DEVELOPMENT NO.:	22017748
APPLICANT:	City of Holdfast Bay
ADDRESS:	Council verge on the western side of the Esplanade roadway opposite 220 Esplanade Seacliff
NATURE OF DEVELOPMENT:	Appeal Report - Case Number ERD-22-000133 in the matter of City of Holdfast Bay vs Council Assessment Panel of the City of Holdfast Bay
ZONING INFORMATION:	Open Space Zone
LODGEMENT DATE:	26 May 2022
RELEVANT AUTHORITY:	Council Assessment Panel of the City of Holdfast Bay
PLANNING & DESIGN CODE VERSION:	2022.9
CATEGORY OF DEVELOPMENT:	Code Assessed - Performance Assessed
NOTIFICATION:	Yes
RECOMMENDING OFFICER:	Alexander Stamatopoulos Development Planner
REFERRALS STATUTORY:	Coast Protection Board
REFERRALS NON-STATUTORY:	Nil

ATTACHMENT 1: Amended plans dated 12/09/2022

Design Amendments

Above: Initial scheme

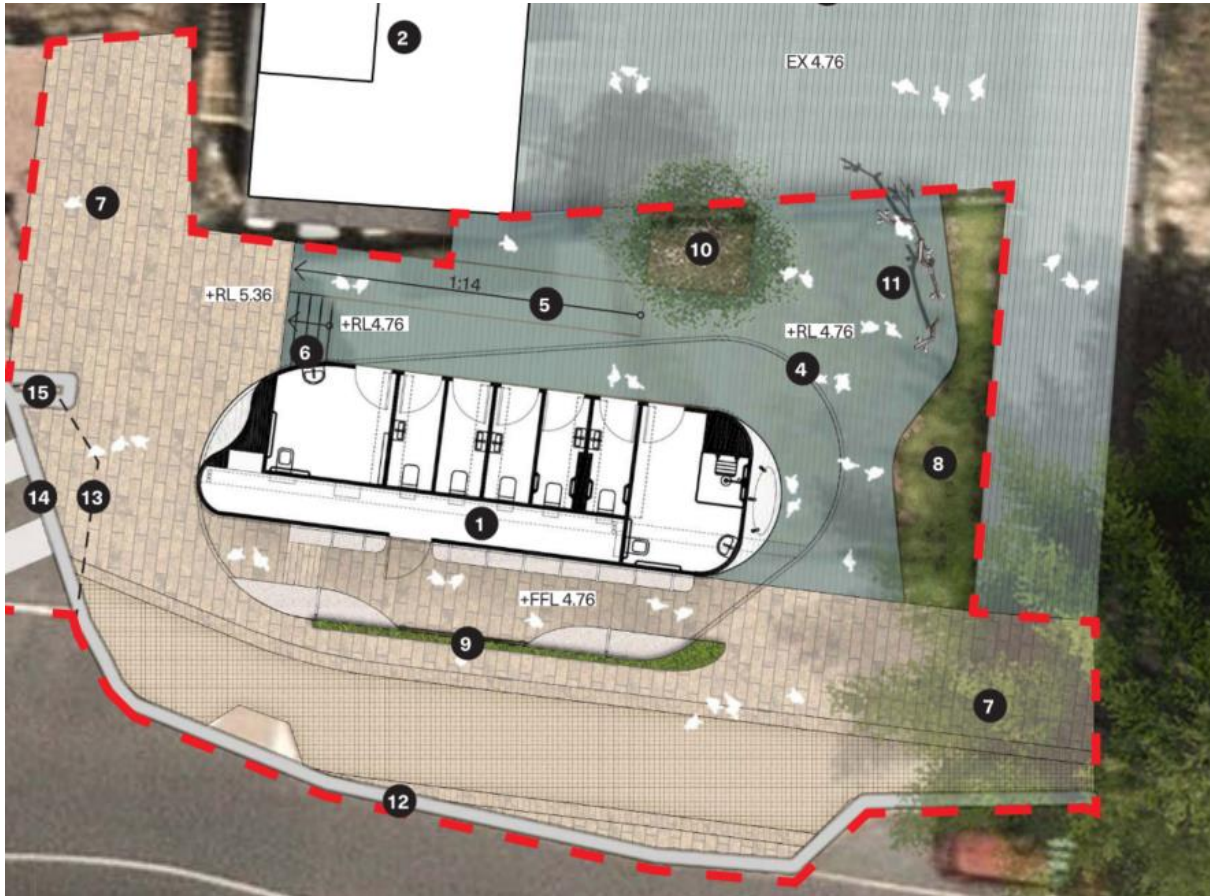
Amended plans were received by the applicant which show a reduction in the overall internal floor area of the structure. The lockers located on the western side of the building have been removed from the scheme. The room hosting the DDA and shower room has been amended which now sits in line with the wall of the store and maintenance room. Attachment 2.3 shows the internal floor plan and roof canopy of the amended building. The architects have outlined the original building footprint in a solid red line and the canopy footprint dashed in red. The same notes are made on the elevation drawings shown on attachments 2.5 and 2.6.

Previous Concept: 52m² ground footprint (101m² canopy)

Amended Concept: 46m² ground footprint (91m² canopy)

Greater permeability created on the eastern façade of the building through a re-designed battened wall

- The semi-permeable timber wall, which housed the lockers, has been deleted as have the battens that projected to the parapet.
- The semi-permeable wall has been replaced with a shorter battened wall, that has been reduced in scale and increased in transparency from the original design. The spacings of the battens have been increased and the area for vine growth has been reduced, allowing greater exposure of the interface between the amenities building and adjoining streets and public spaces.
- The space above the battened wall has been kept open to increase visibility, air flow and natural light, permitting sufficient views from passing traffic and eliminating the potential in creating a dark and secluded area.

Building footprint reduced to create more open space

- The amenities building store/maintenance area and northern façade have been significantly reduced to decrease the bulk of the building, creating a larger, open space to the north.
- The canopy of the building has also been reduced to limit the impact of the roof line on nearby vistas and to expand unimpeded sightlines.
- Increased greening areas have been created as a result, maximising the opportunity for planting to improve translucency and softening in and around the building, in lieu of bold, solid elements.
- The corner-less footprint of the building avoids creating 'blind spots' and limits opportunity for anti-social behaviour.

Relocation of outdoor basin to increase accessibility and visibility

- The outdoor basin has been relocated to the northern end of the building, increasing visibility from the east. Originally the outdoor basin location was obscured by the northern façade, however this has been re-designed and re-located to a central location.

The reduction of the building size sees a change in floor area from 52sqm to 46sqm. The decrease in area is noted on the northern side of the building which sees an increase in open space and therefore a larger capture of views from the adjacent lower level buildings satisfying PO 2.1. This has also resulted in an increase in soft landscaping which is a welcome addition to the hardscaped decking area.

The canopy reduction of 10sqm is also notable contributing to the minimisation of the overall scale of the structure. The canopy still overhangs the building providing shelter, however, provides a sense of openness as the lower level walls are well recessed in to the south. The size of the building contains a floor area of 46sqm well below the 80sqm anticipated by DPF 2.2. The scale of the building alleviates visual impacts of buildings on natural and landscape features satisfying PO 2.2 of the Open Space Zone.

The battened wall has been reduced in scale and increased in transparency which will allow for greater passive surveillance, air flow and natural light. The water basin is now located on the northern elevation of the building which is now visible from the east and western sides. The changes made satisfy DO 1(c) and PO 2.1 of Design in Urban Areas.
